APPENDIX O2

Design Deviations

I-405, SR520 to SR522 Stage 1 (Kirkland Stage 1)

Draft RFP

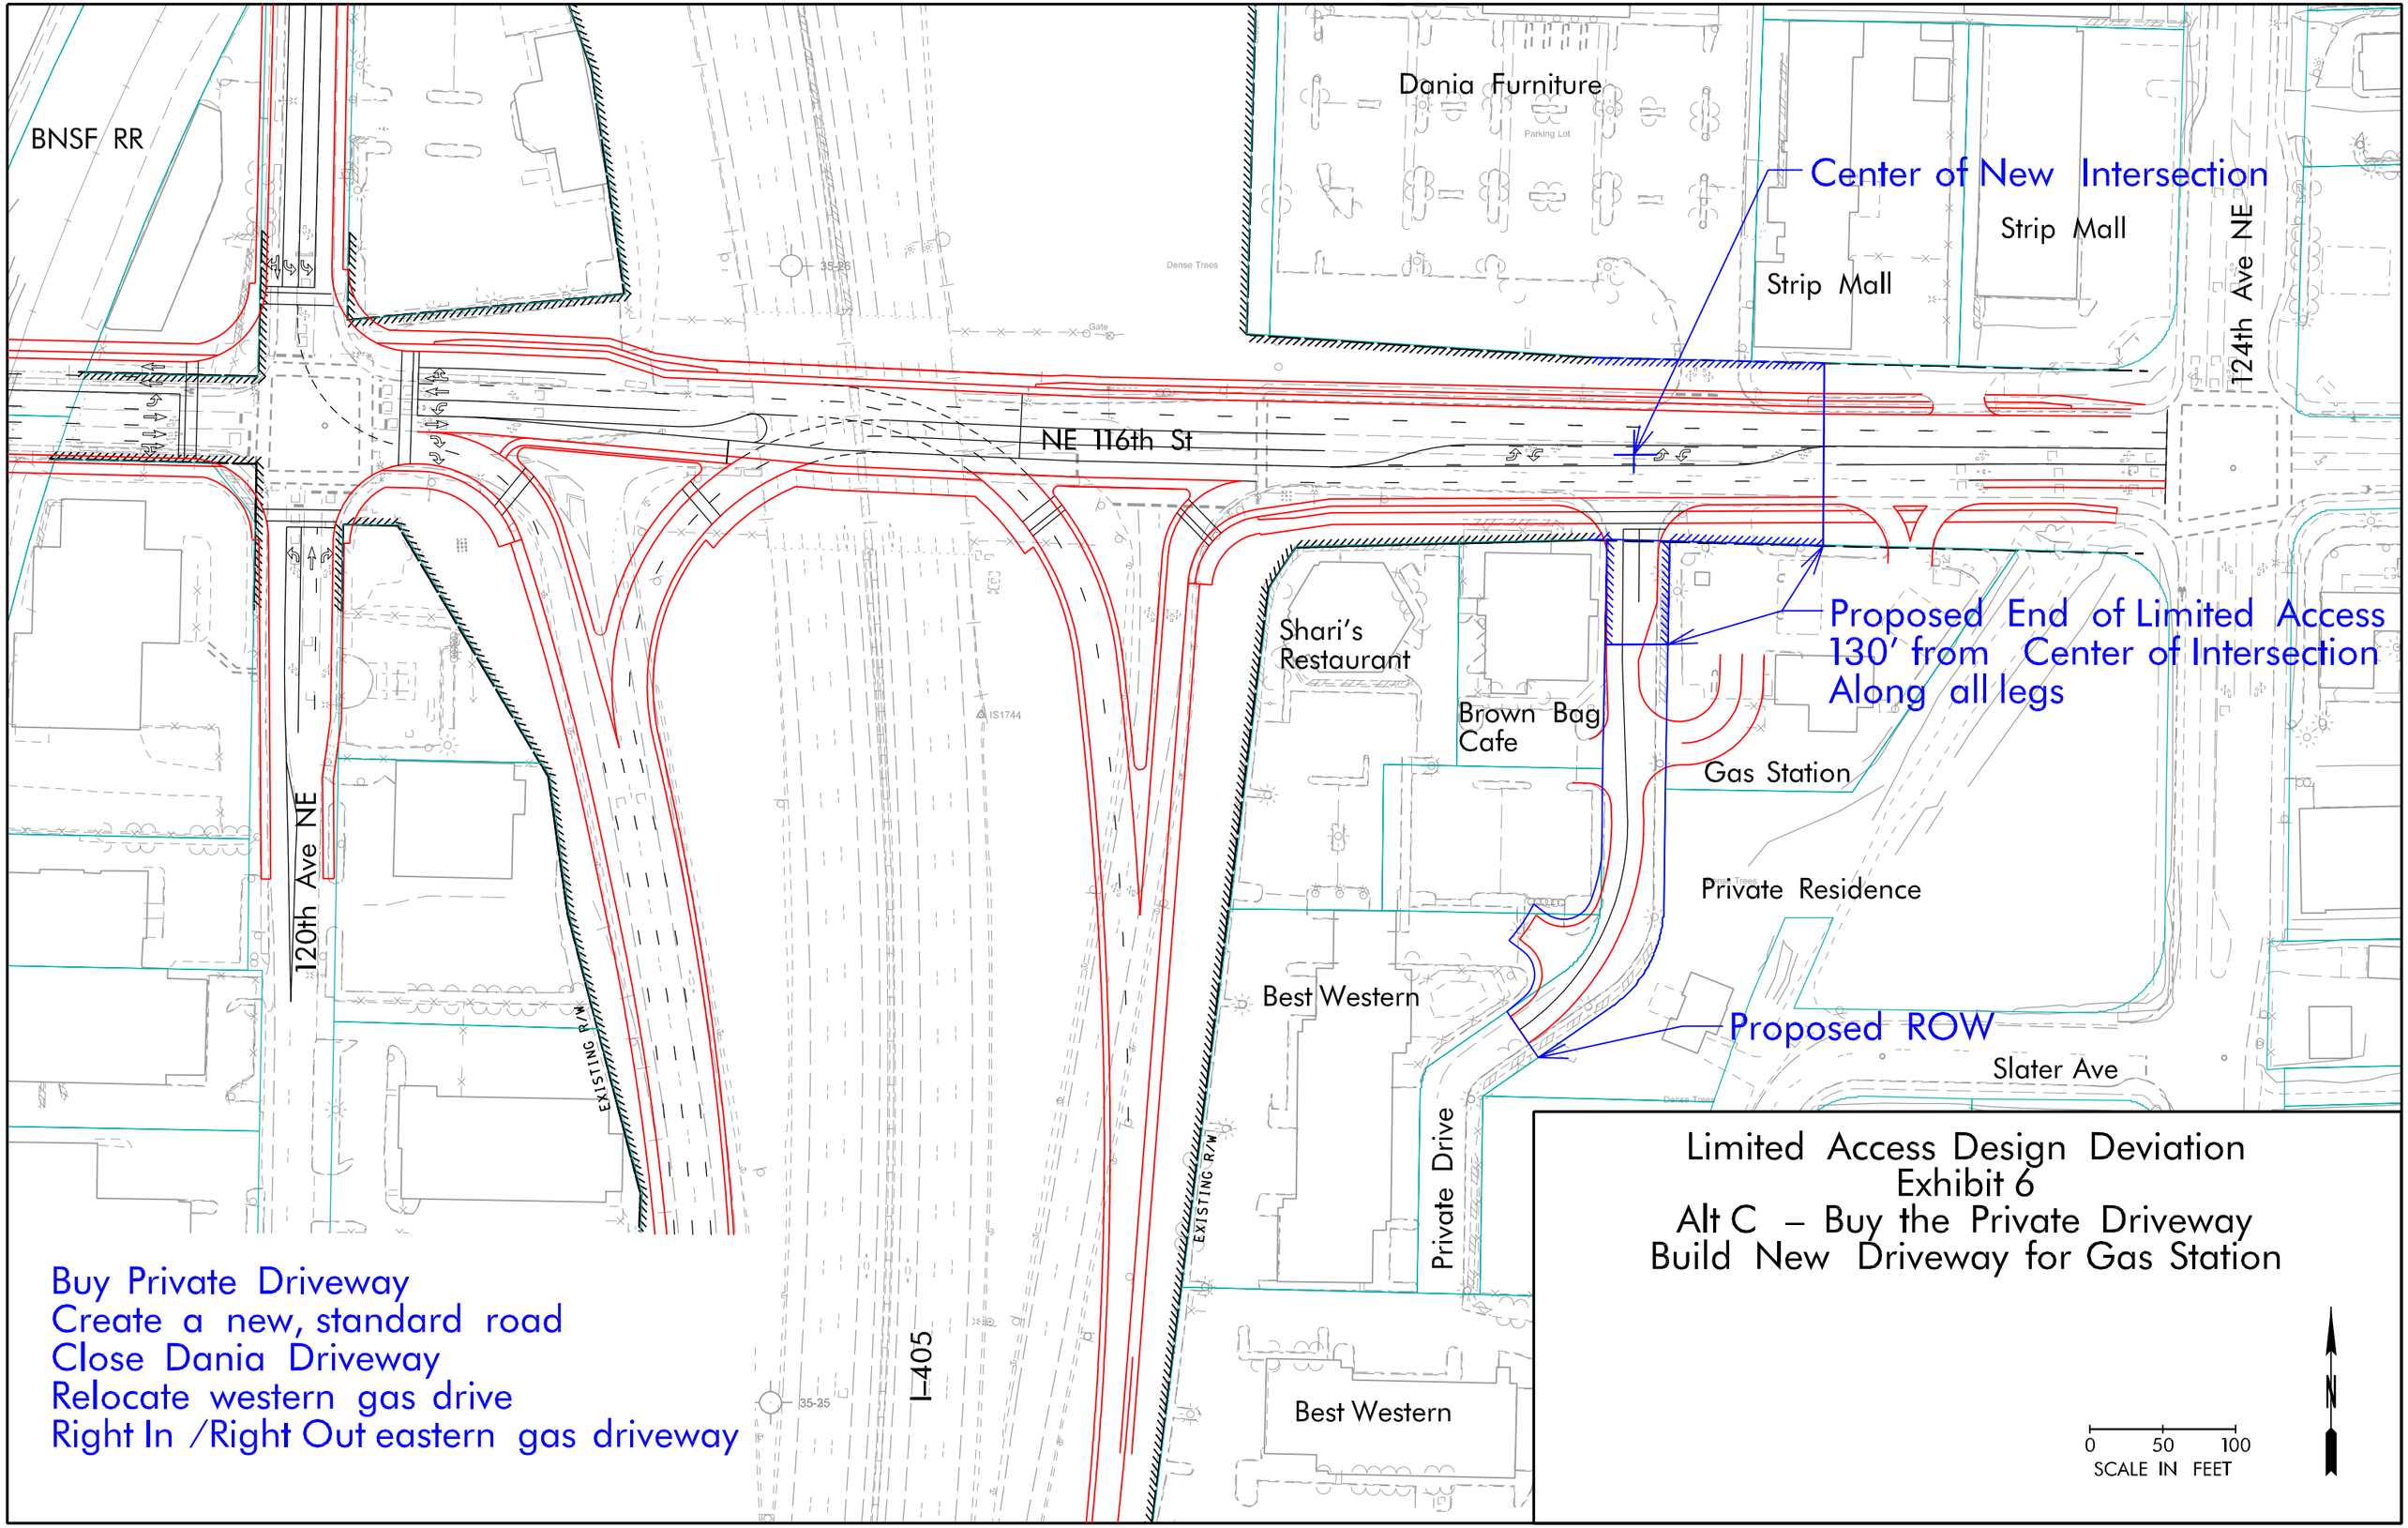
Alternative C Buy the Private Driveway (Exhibit 6) – This alternative would purchase the private driveway to create a new public road. The road would be deeded to the City of Kirkland to maintain and operate. Improvements would be necessary to upgrade the driveway to a road with a 25 mph design speed, including increasing the curve radius and installing a turnaround. The new road would be stop controlled with a right turn pocket and a left/through lane.

Since the new road is within 350 feet of the limited access measurement point, an additional 130 feet of access control would be necessary along each leg of the intersection. The western gas station and the Dania driveway would both be affected by the new limits of limited access. The western gas station driveway would be closed and a new access opened onto the new road, approximately 200 feet from the center of the intersection. Standard access to the Dania driveway could not be provided. Either the

Buying the private drive to turn it into a public road (Alternative C, Exhibit 6) results in an intersection within 350' of the ramp and requires purchasing limited access for 130 feet along all legs of the new intersection. The Dania driveway would be closed and one access to the gas station relocated to the new road. Relocating the gas station driveway may still result in a condemnation if the tankers are unable to navigate the new access. The total cost of this option is $2.3 million. It would also result in approximately 3 years of schedule delays to acquire all the necessary access rights and could result in clean-up of a HAZMAT site.

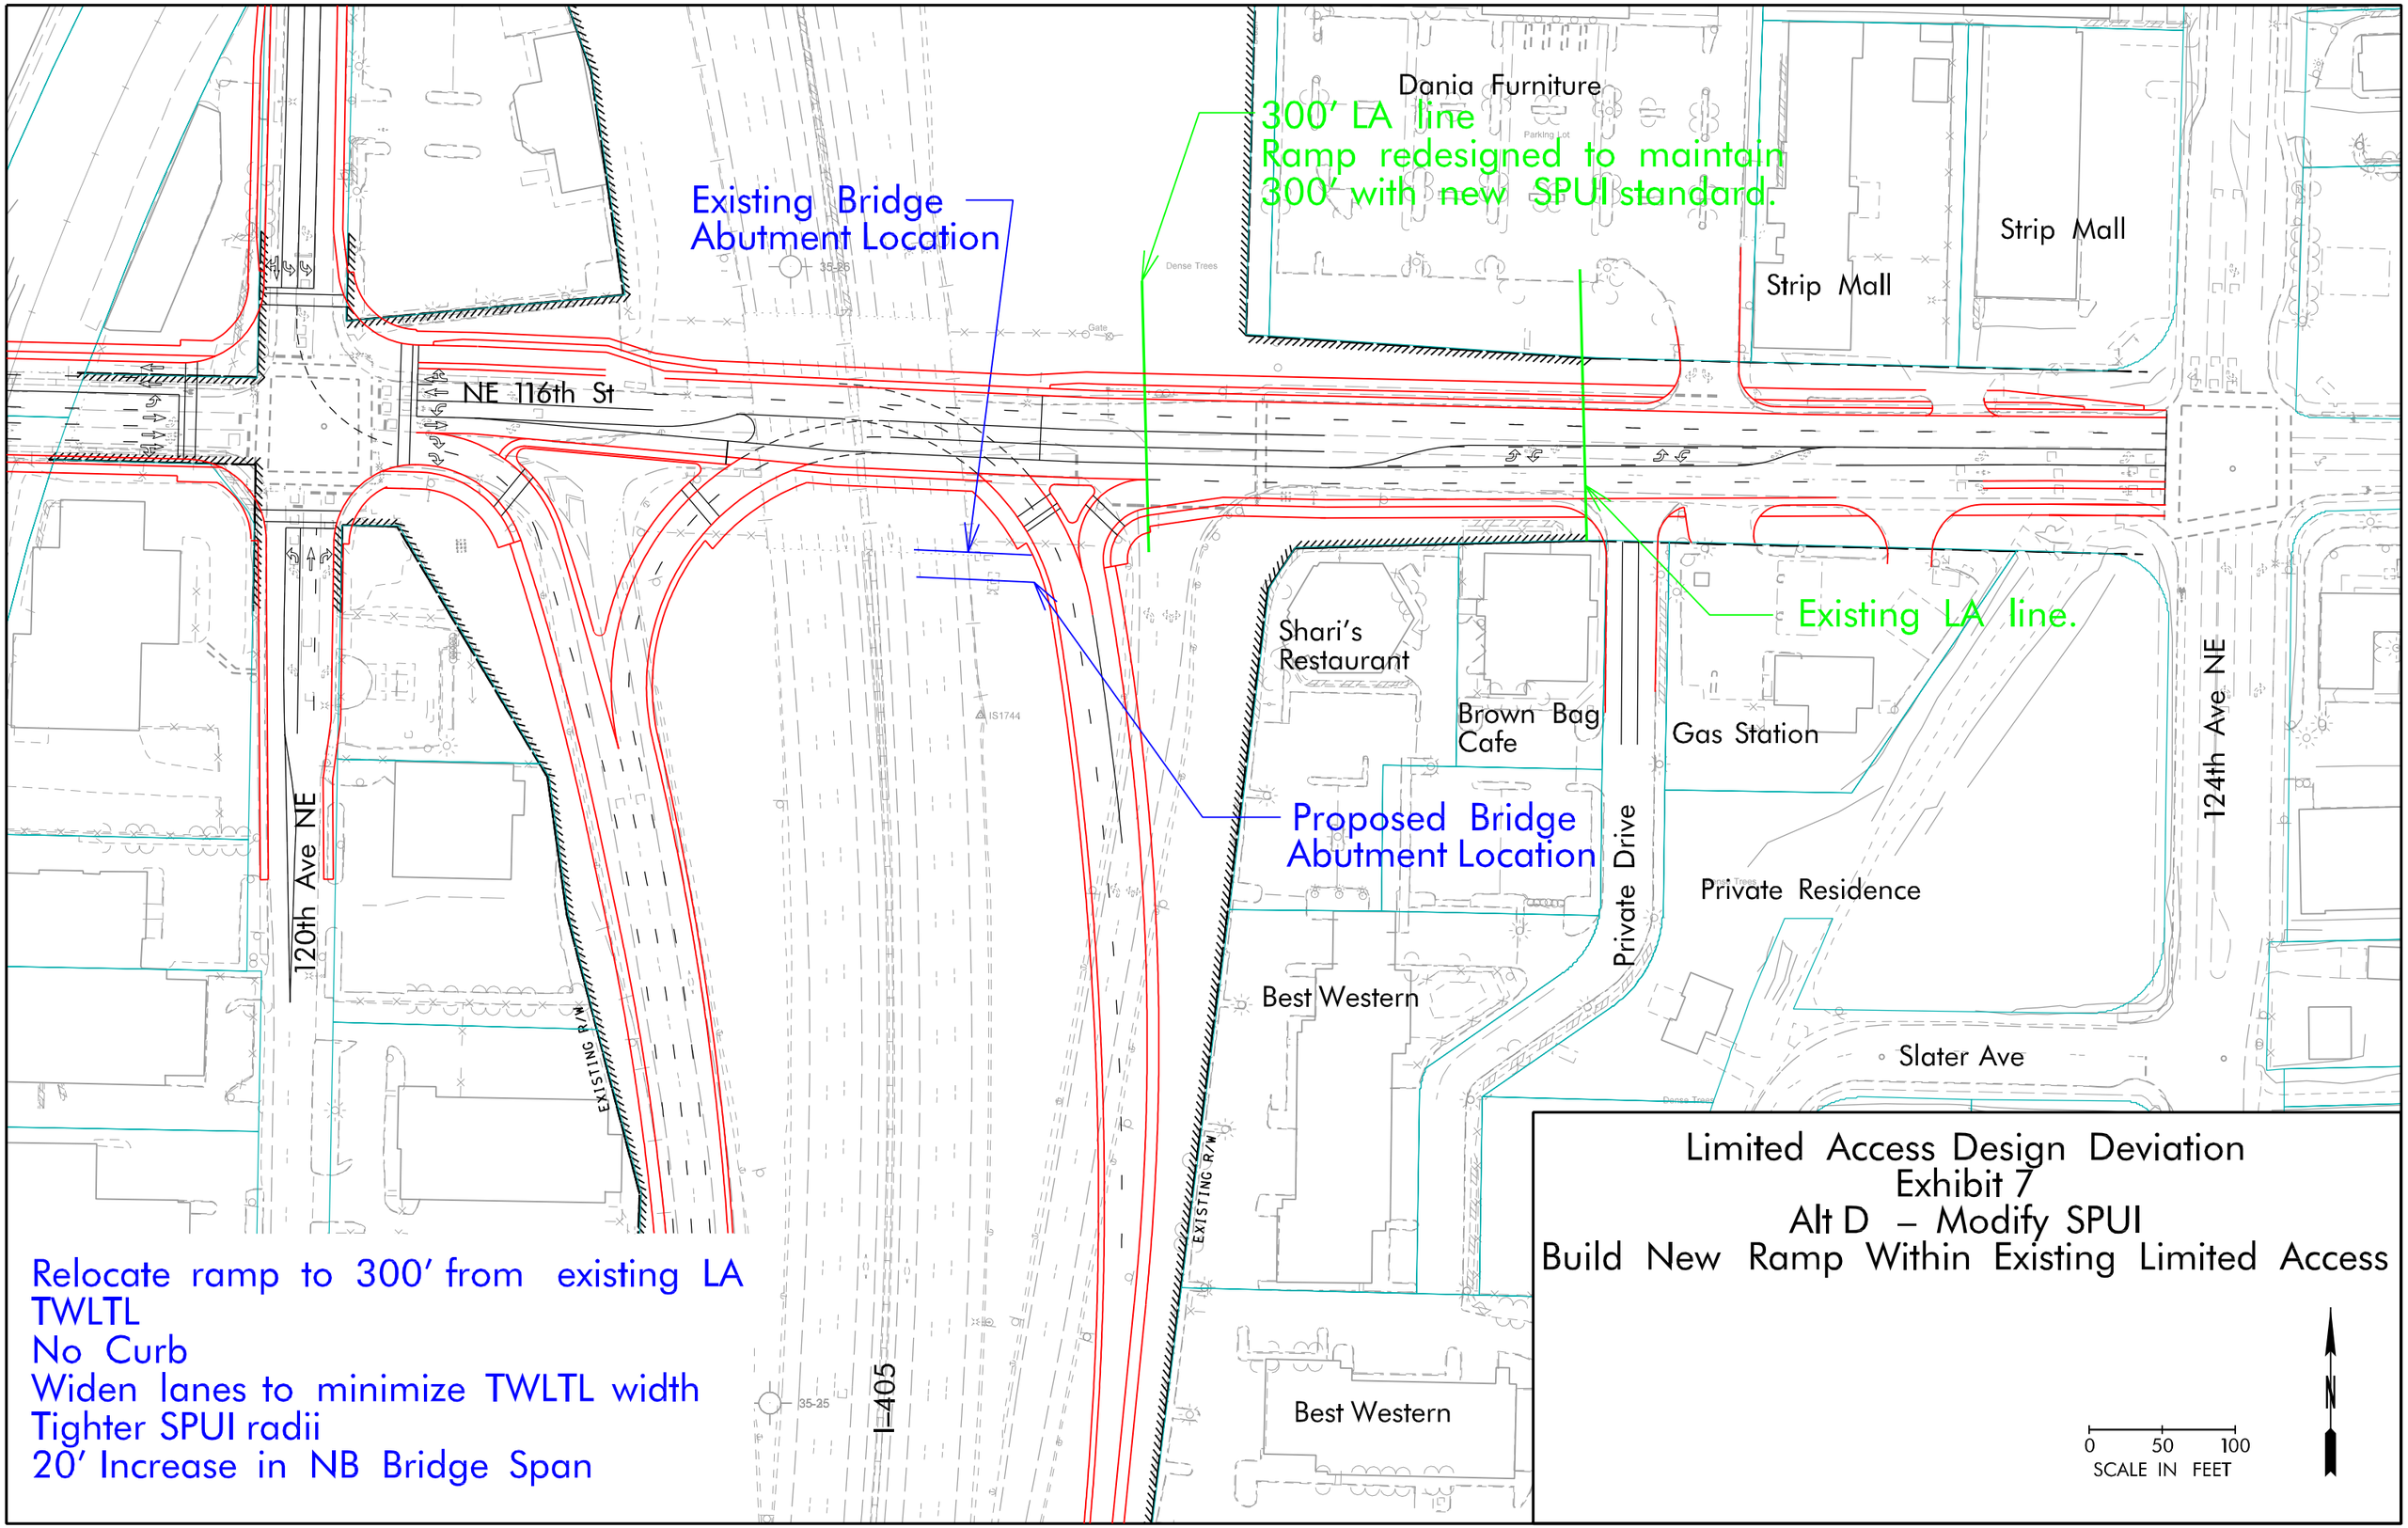
Alternative D Modify SPUI-Build New Ramp within Existing Limited Access (Exhibit 7) – This alternative will replace the existing half-diamond interchange with a tight half-SPUI interchange. The tighter half-SPUI ramp design would situate the reference point for limited access measurement in the same location as the existing configuration, eliminating the need to purchase additional access control. The radius for the left turning vehicles is the minimum necessary to meet the design speed through the SPUI (160 foot radius for a 25 mph design speed). The right turn pocket needs a 35 foot radius to match the limited access reference point, which is the design standard for a passenger vehicle. The right turn pocket would be widened and tapered to allow a WB-50 truck to complete the turn, though a WB-67 truck would encroach into the second lane to complete the turning movement.

Squeezing the SPUI ramp into the existing limited access area is not an optimal design for the NB off ramp. In order to build a ramp without increasing the span length of the bridge beyond its current limit, the storage length on the ramps would need to be decreased. Based on traffic models of design year (2030) conditions, this ramp configuration would not provide sufficient storage length for left turning vehicles, while queuing in the right turn lane could interfere with the operation of the SPUI. Increasing the span length of the bridge to increase the ramp storage length results in inefficiencies in the structure type and depth, an unpleasant appearance for the interchange, and the potential for pedestrian discomfort with the offset bridge abutments. Both the NB and SB bridges over NE 116th St. would need to be lengthened to meet the Context Sensitive Solutions (CSS) guidelines for the corridor. The total cost of lengthening the bridge span is approximately $1 Million, including soft costs, inflation and a contingency.

Tightening the half-SPUI ramps to remain within the existing limited access (Alternative D, Exhibit 7) would align the measurement points for the proposed and existing limited access in the same place. The tighter half-SPUI ramp design would eliminate the need to purchase additional access control. This alternative was not selected because in order to provide sufficient storage on the off- ramp the NB bridge would have to be lengthened, increasing bridge cost significantly and degrading the operations of the interchange significantly. This alternative was approximately $1 million.
